HISTORIC AND DESIGN REVIEW COMMISSION

HDRC CASE NO: 2018-446
ADDRESS: 925 BURLESON ST
LEGAL DESCRIPTION: NCB 1302 BLK 3 LOT 18
ZONING: R-5, H
CITY COUNCIL DIST.: 2
DISTRICT: Dignowity Hill Historic District
APPLICANT: Mario Herrera
OWNER: Chris Lee
TYPE OF WORK: Rehabilitation, construction of a rear addition, exterior modifications
APPLICATION RECEIVED: August 31, 2018
60-DAY REVIEW: October 30, 2018
REQUEST:

The applicant is requesting a Certificate of Appropriateness for approval to:

FRONT ELEVATION
SCALE: 1/4" = 1'-0"

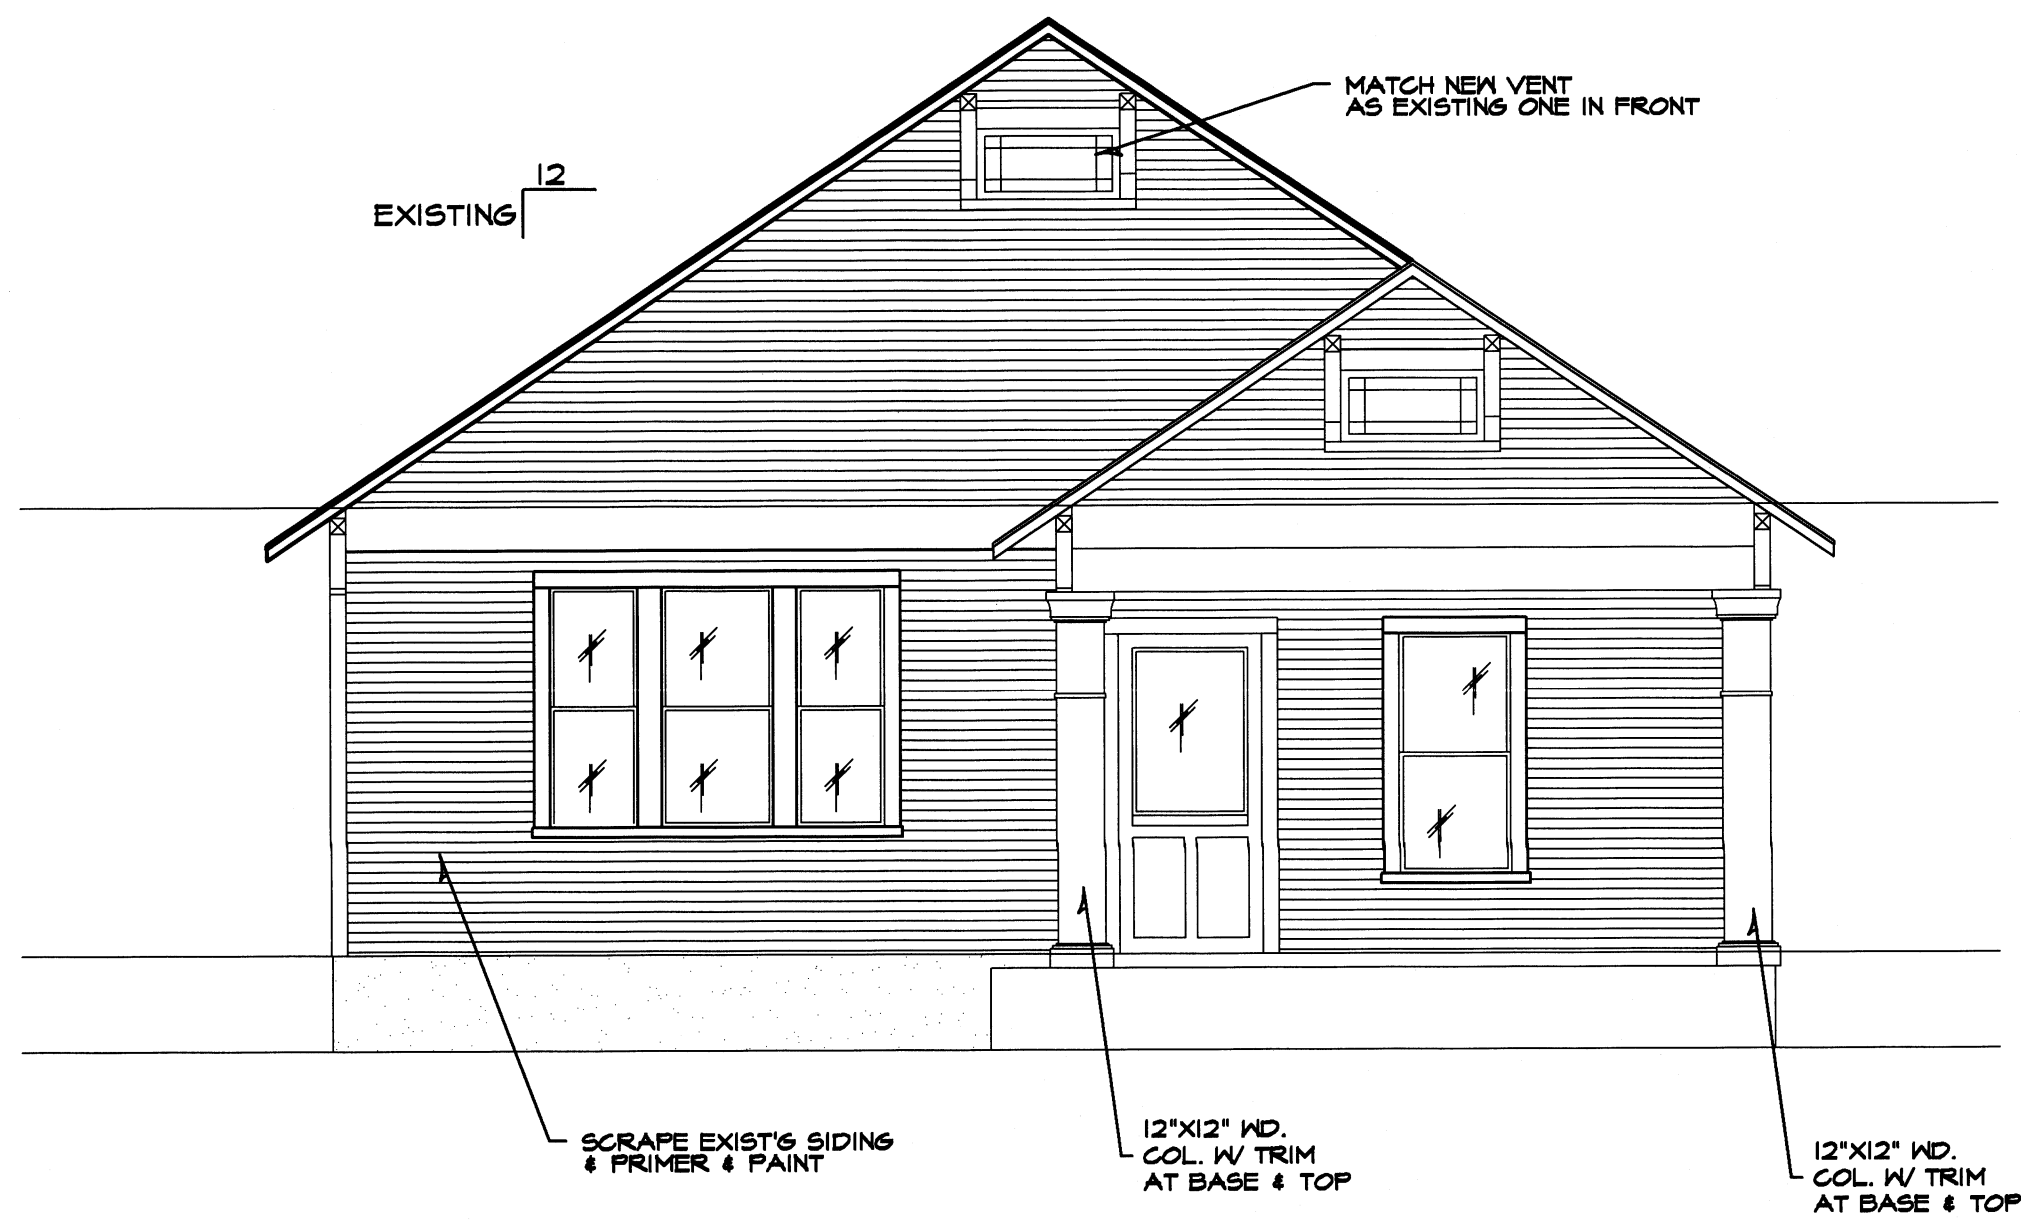
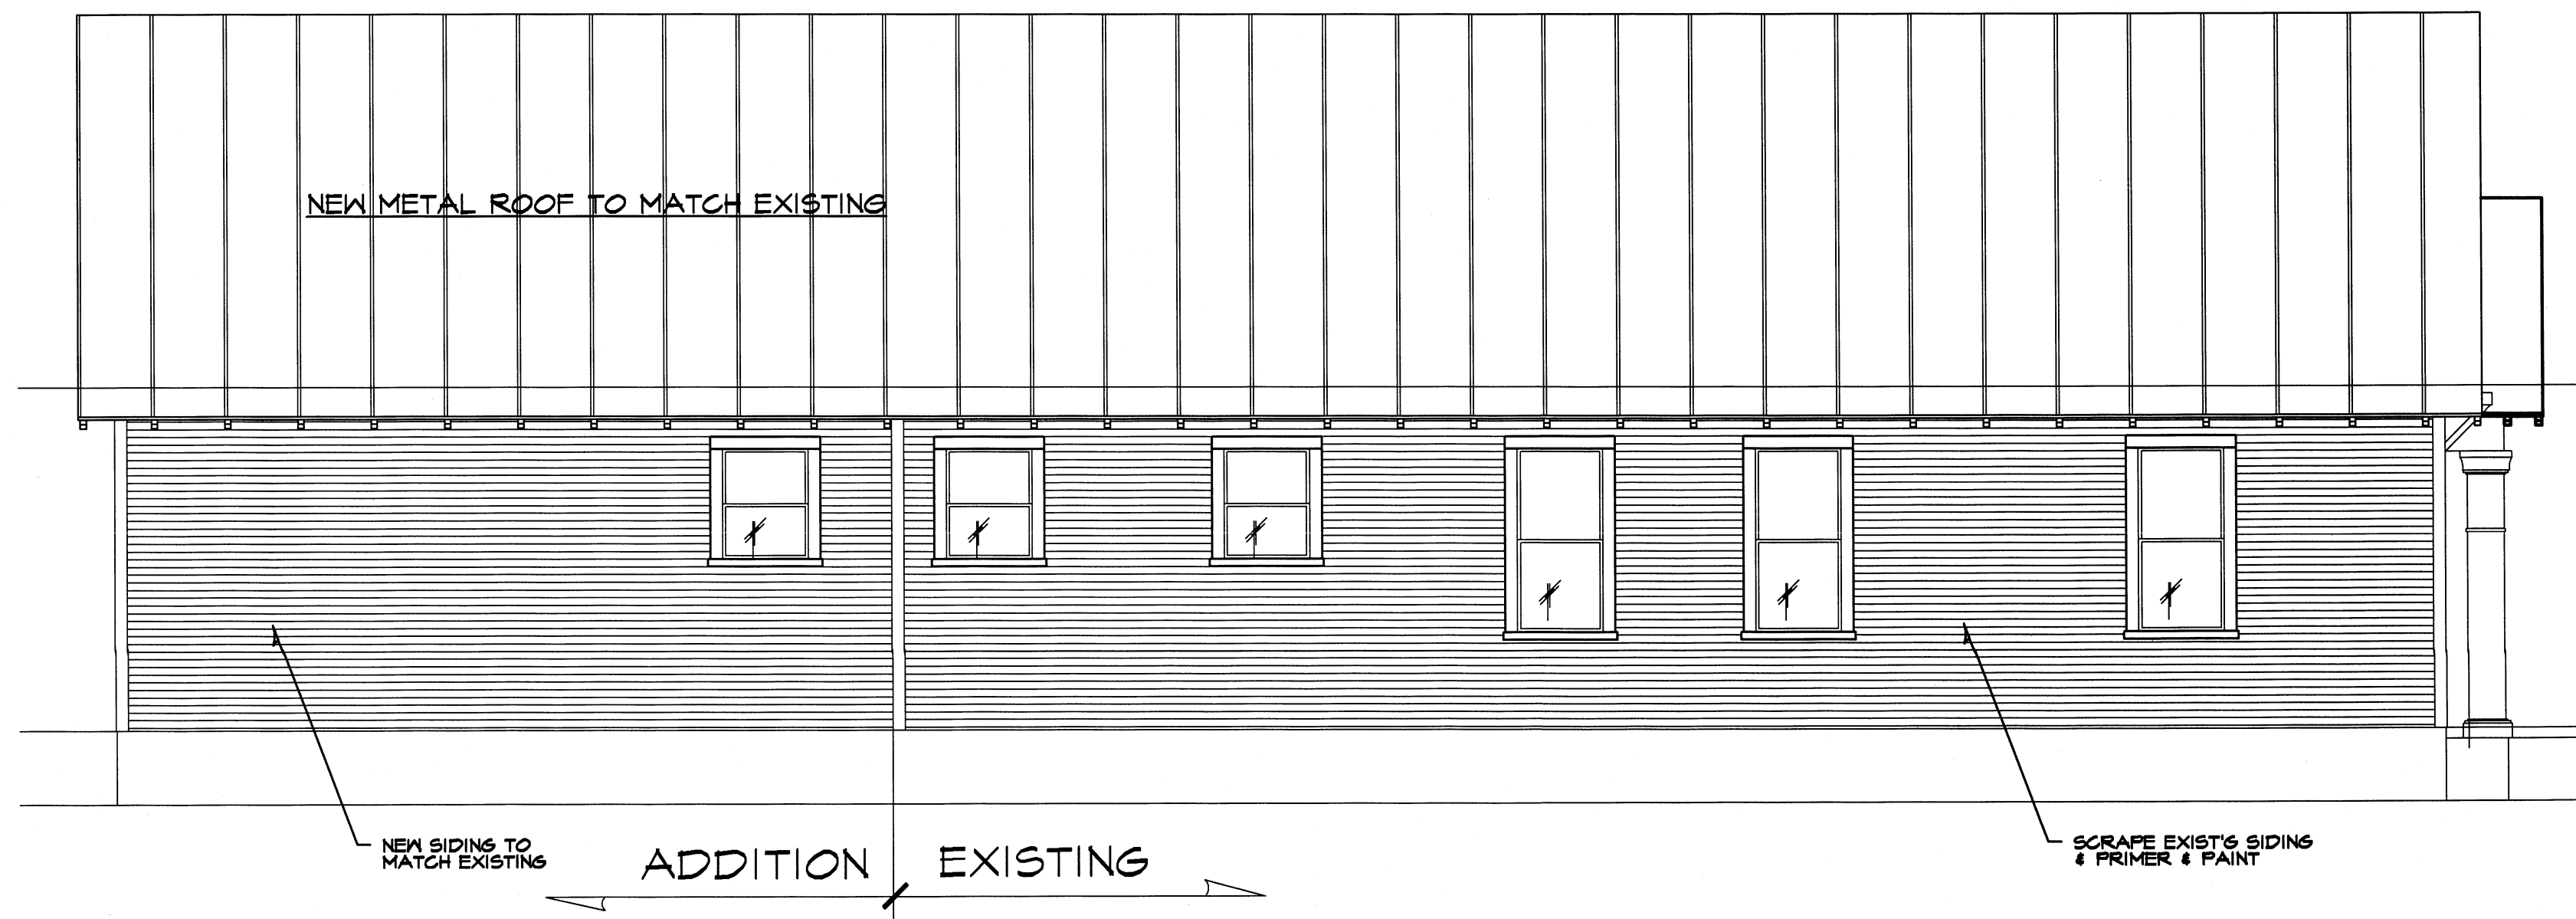
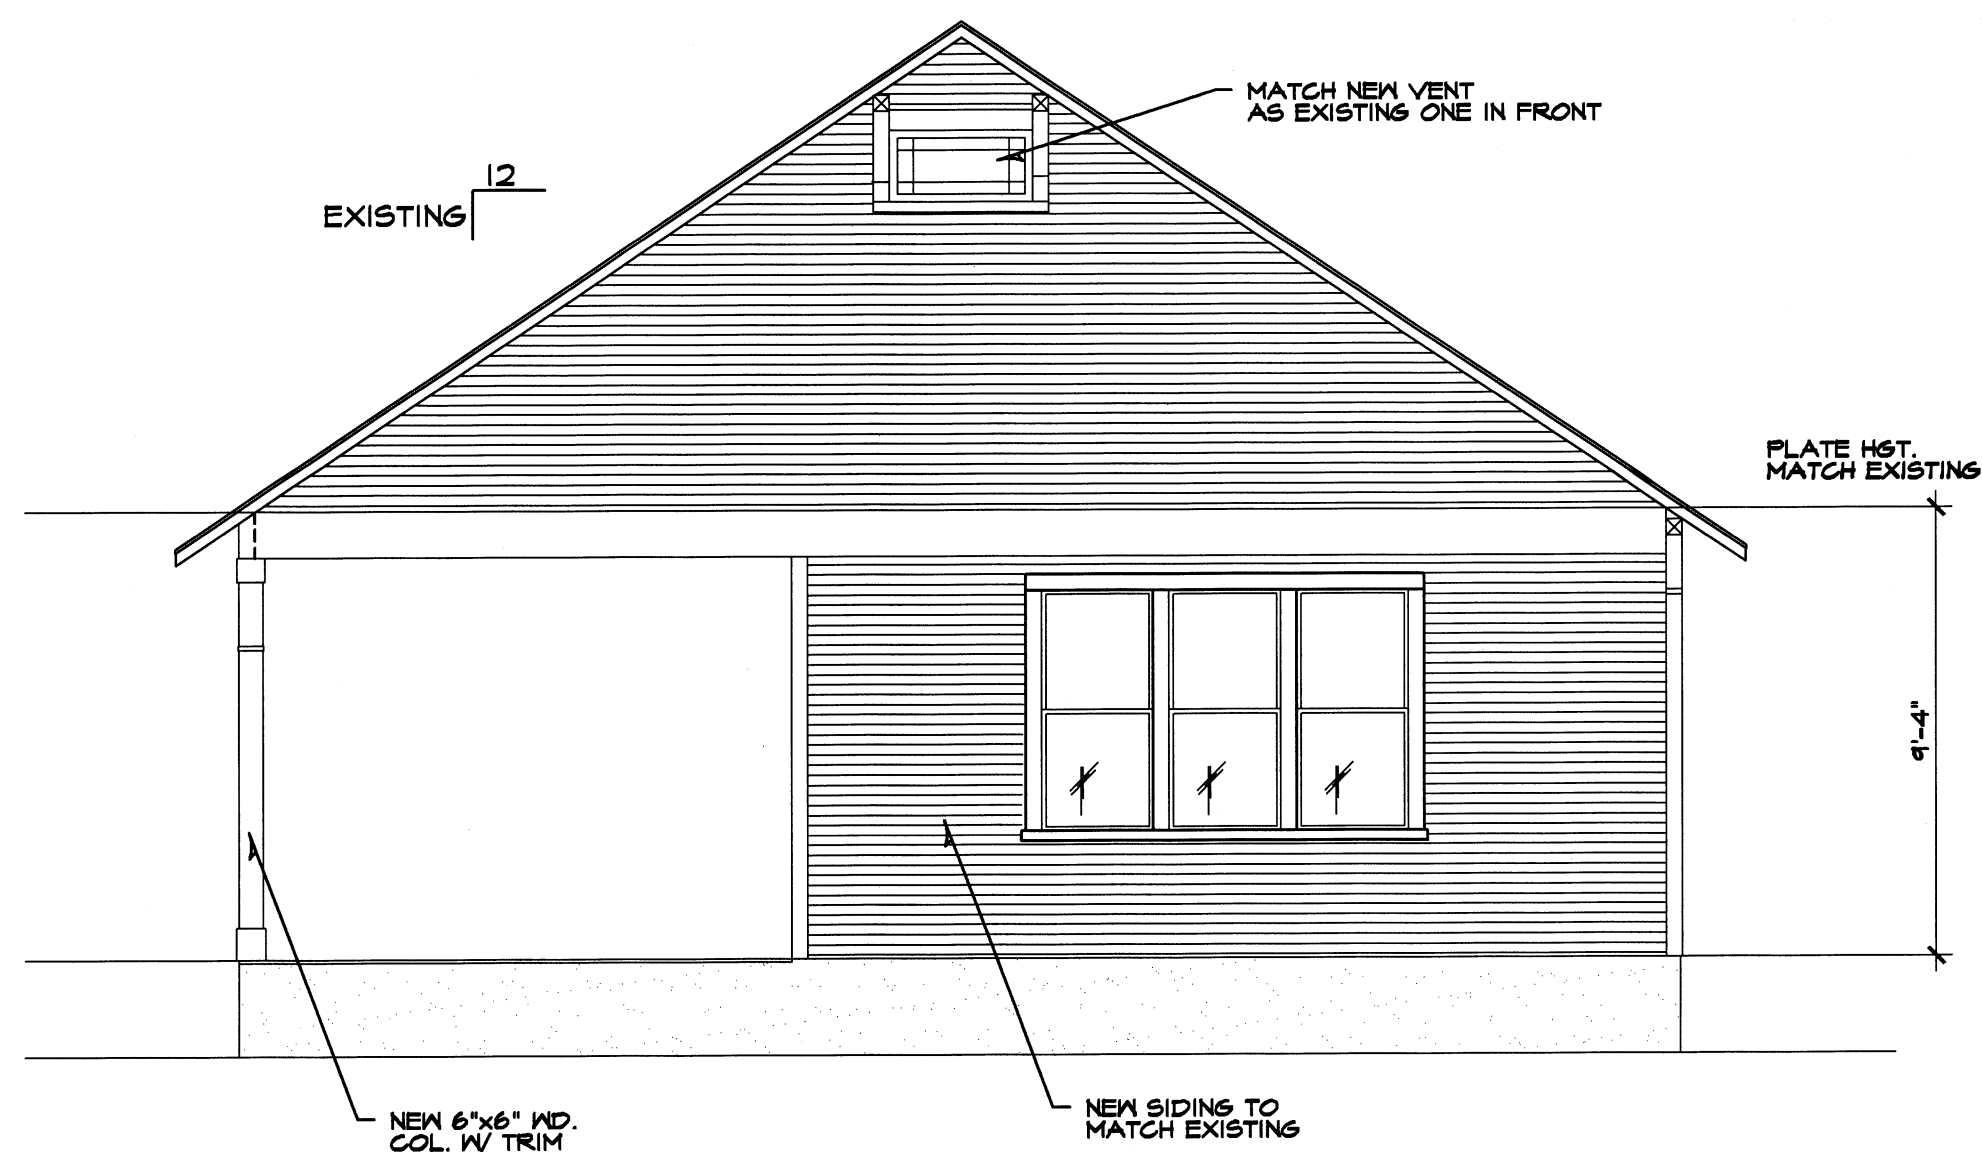
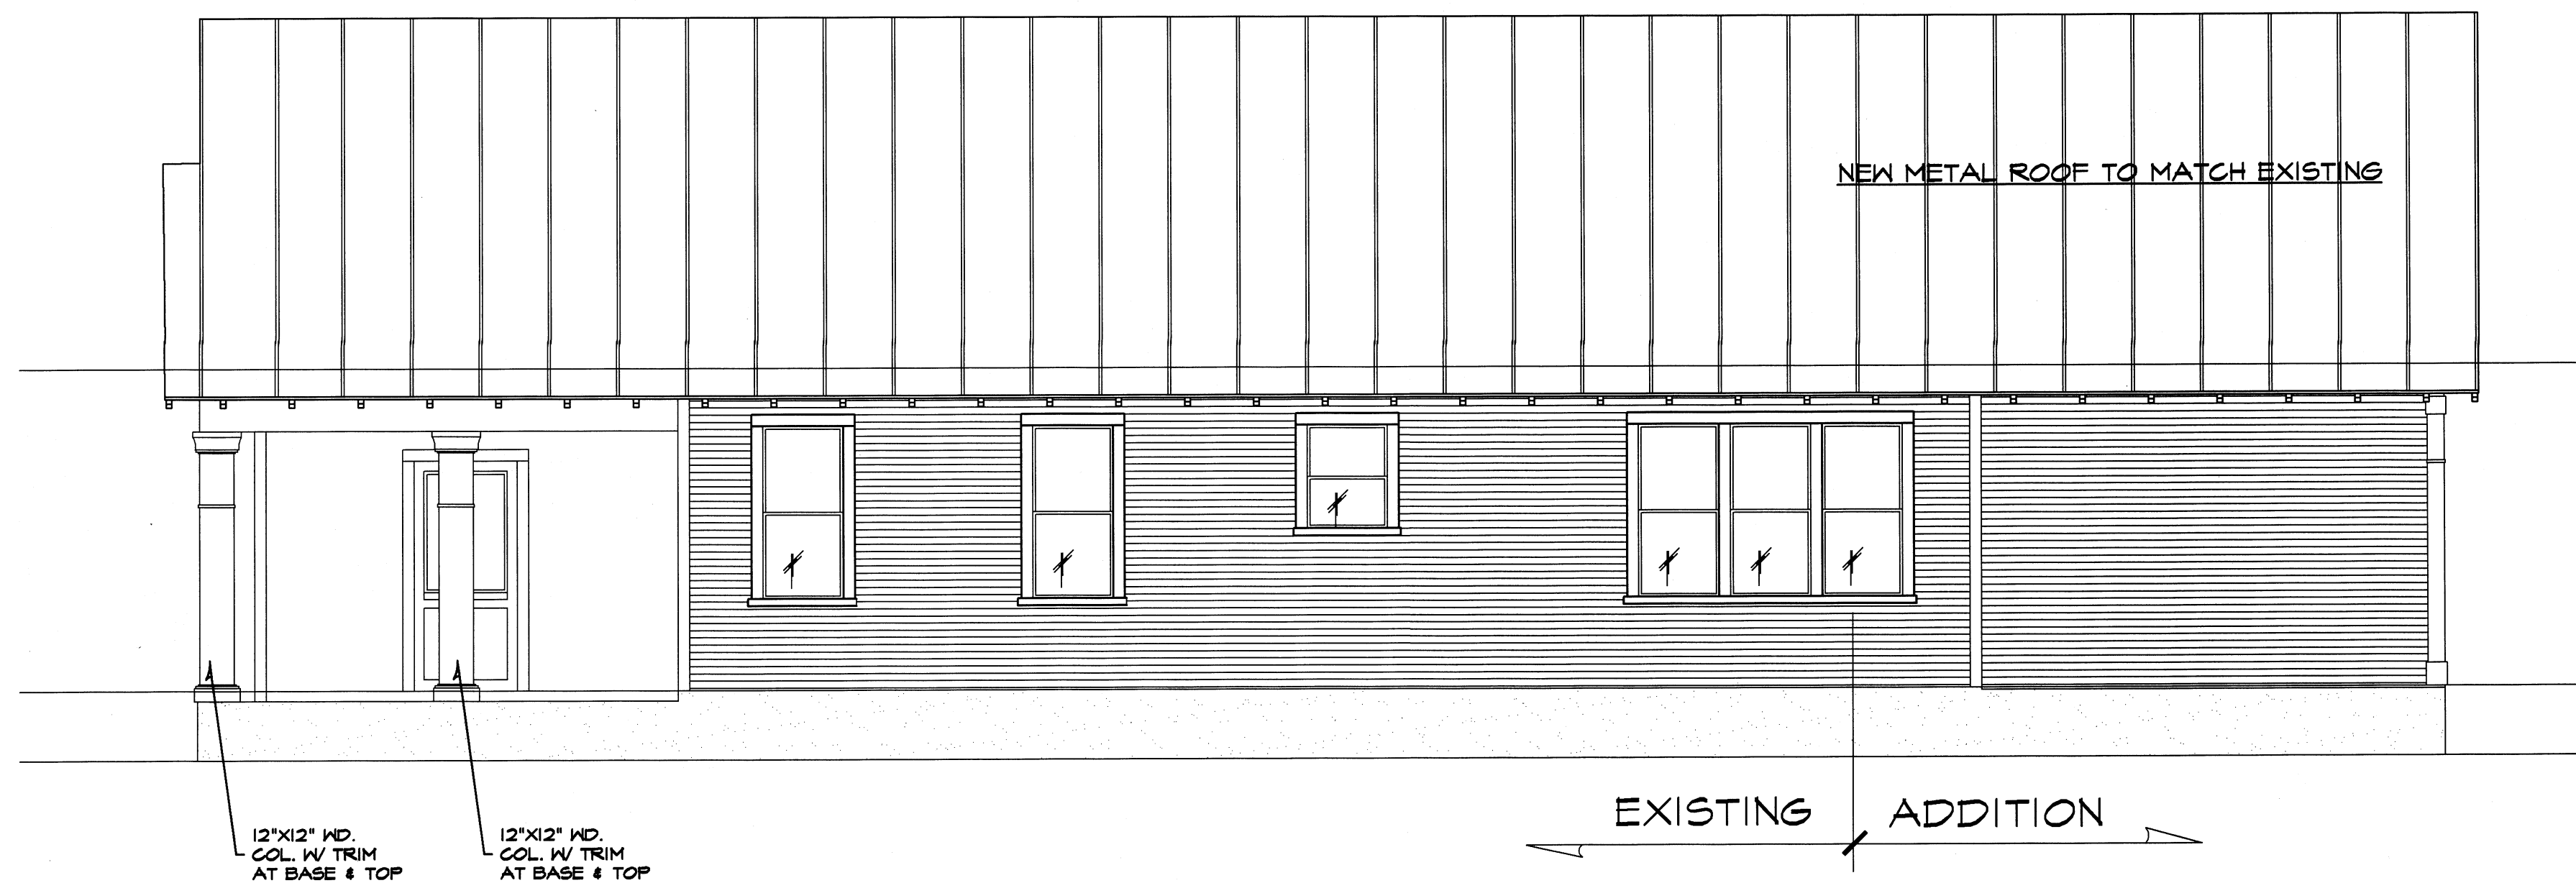
- c. ATTIC VENT – The applicant has proposed to remove the existing, window located in the place of the original attic vent and install a vent matching the remaining, original vent over on the porch gable. Staff finds the removal of the existing window appropriate; however, the vent should feature a profile comparable to that found on the neighboring historic house at 923 Burleson.

- d. PORCH COLUMNS – The historic structure currently features wrought iron porch columns. The applicant has proposed to install twelve (12) inch square porch columns with capital and base trim. Staff finds the removal of the existing, wrought iron columns to be appropriate; however, the applicant should install architecturally appropriate columns. The historic structure at 923 Burleson is of the Craftsman style and a close match to the structure at 925 Burleson is regards to roof form, massing, window and door locations and architectural detail. Staff finds that columns comparable to those found at 923 Burleson, featuring a pediment with a 117 siding profile and square columns would be most appropriate. A detailed drawing should be submitted to staff for review and approval.

- g. ROOF FORM – The applicant has proposed a rear facing gabled roof to match that found on the front façade. Staff finds the proposed roof form to be appropriate.

- i. MATERIALS – The applicant has proposed to match the existing materials, 117 profile siding and match the existing, standing seam metal roof. The applicant has not specified window materials at this time. Staff finds that wood or aluminum clad wood windows should be installed that feature meeting rails that are no taller than 1.25” and stiles no wider than 2.25”. White manufacturer’s color is not allowed, and color selection must be presented to staff. There should be a minimum of two inches in depth between the front face of the window trim and the front face of the top window sash. This must be accomplished by recessing the window sufficiently within the opening or with the installation of additional window trim to add thickness. Window trim must feature traditional dimensions and an architecturally appropriate sill detail. Window track components must be painted to match the window trim or concealed by a wood window screen set within the opening.

- 2. Staff recommends approval of item #2, attic vent replacement based on finding c with the following stipulations:
 - i. That the proposed gable vent match the profile of the vent at 923 Burleson and that the applicant submit updated information to staff for review and approval.

- 3. Staff recommends approval of item #3, column replacement based on finding d with the following stipulations:
 - i. That columns comparable to those found at 923 Burleson, featuring a pediment with a 117 siding profile and square columns be installed. A detailed drawing should be submitted to staff for review and approval.
